City of Alamogordo

Re: **Addendum 2**
Public Works Bid No. 2021-003
Scenic Drive Extension to Mesa Verde Ranch

Addendum Number 2 is issued to provide changes and/or clarifications to the questions asked on the above referenced bid. Date, time, and location of submitting this bid remains unchanged.

CONCRETE RADIUS FILLET DETAIL
NOT TO SCALE

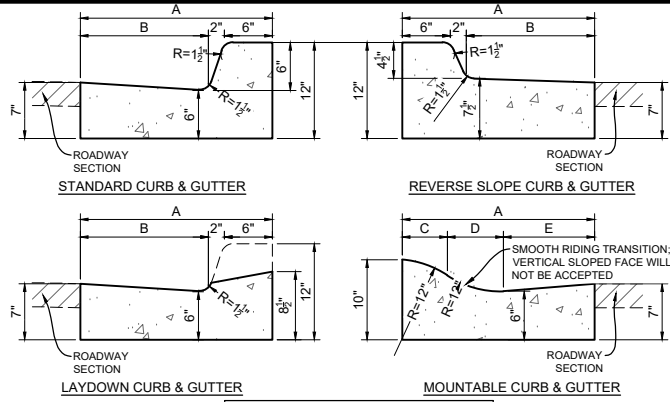
Question 6 – Summary of Work Details (Sheet 1-3): 4", 6", 8" Concrete Pavements states that "concrete fillets will be paid as 6" Concrete Pavement." All fillet drawings state that the fillets are to be 8-inch. You have 8" Concrete Pavement line item. In which line item do the concrete fillets get paid.

Response 6 – The Summary of Work Details for Concrete Pavement 4", 6", 8" and Median Pavement incorrectly states that concrete fillets will be paid as 6" concrete pavement. **Concrete fillets will be paid as 8" Concrete Pavement.**
